# TOWN OF UNDERHILL

## Development Review Board

MARTY BASLOW  
PRELIMINARY & FINAL SUBDIVISION REVIEW  
Docket #: DRB-19-10

<b>Project Proposal:</b>	Preliminary & Final Subdivision Review of Marty Baslow for a proposed 2-Lot subdivision of property located at the aforementioned address.
--------------------------	--

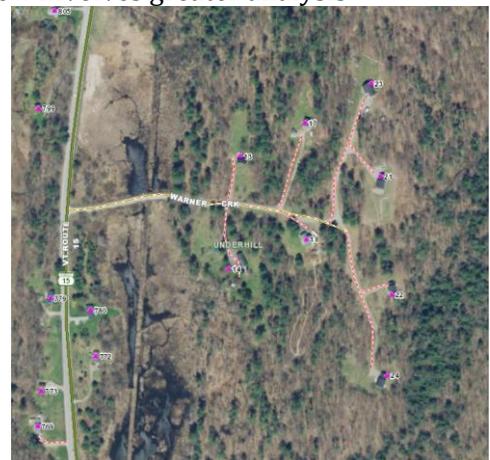
- Lot 5B has ±878 ft. of frontage along Baslow Lane (as identified by the E911 Website); however, Baslow Lane, the development road would technically ends after the driveway to the first residence – 4 Baslow Lane, which would be approximately 120 feet of frontage.

- Depending how the Board applies the frontage standards, frontage may or may not be an issue, as a large portion of the frontage for Lot 5B could potentially be considered measured along a shared driveway and not along a development road.

- If the Board interprets frontage along only the portion of Baslow Lane from Gerts Knob to 4 Baslow Lane, the subject property will fail to satisfy the 250 ft. requirement, as the lot will only contain ±120 ft. of frontage.

- Lot frontage can be waived in accordance with §§ 3.7.F.3.a and 8.6.A.2.a if the lot is accessed by a shared driveway – in this case, while the road is identified as Baslow Lane, the shared driveway would commence after the driveway for 4 Baslow Lane.

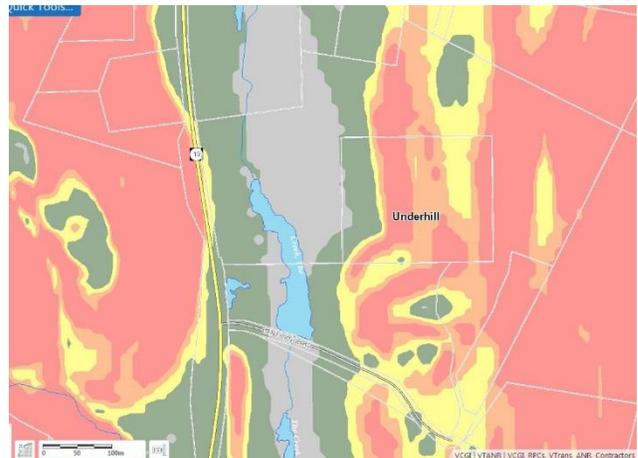
- Areas of steep slopes (15-25%) are present on the existing lot (see directly to the right).
- Based on the site plan relating to Lot 5A (see Exhibit L), in relation to the ANR Atlas Steep Slopes map (directly to the right), the site for the single-family dwelling (though for representation purposes) appears to be situated in an area that is less than 15%.
- The proposed site plan relating to Lot 5B (see Exhibit M), depicts areas of very steep slopes (>25%); however, the proposed single-family dwelling is not located in one of these areas.
  - While the proposed dwelling site is not in very steep slopes, the Board should ask the Applicant if the site contains steep slopes (15%-25%). If so, then the Board should determine whether to perform a more detailed analysis at this time

- The driveway serving Lot 5A does not appear to impact steep slopes (15%-25%) or very steep slopes (>25%), and should be verify during the site visit on September 19, 2020.
- The driveway serving Lot 5B, which will utilize an existing wood’s road, appears to impact steep slopes and very steep slopes.
  - The Applicant has provided a driveway profile (see Exhibit P); however, the Site plan does not depict a final grade of the driveway.
